SB Number:	SB 2C9-016	Creation Date: 05/02/2005
Subject:	Unsuccessful detection of paper size in lengthwise direction	
Model:	KM-1620

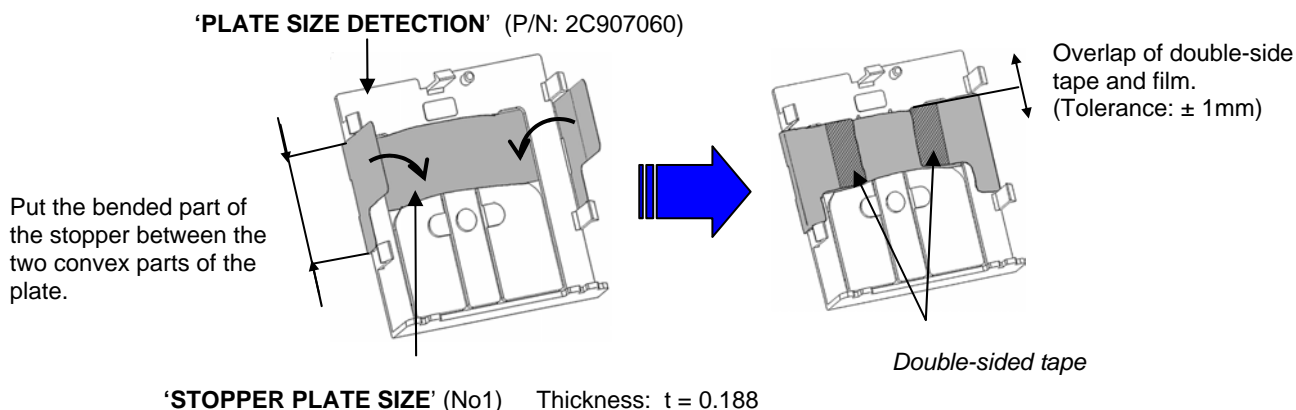
Paper sizes which are positioned in lengthwise direction in the cassette might not be correctly detected due to possible deformation of the 'PLATE SIZE DETECTION' (P/N: 2C907060). Due to this deformation the 'PUSH SWITCH 03 SN' (P/N: SP000360) that detects paper size in lengthwise direction in cassette is located at improper position.

The 'STOPPER PLATE SIZE' (No.1) has been attached to the 'PLATE SIZE DETECTION' in order to prevent the deformation of 'PLATE SIZE DETECTION'.

If the phenomenon arises, please attach new part no. 1 (see below parts table).
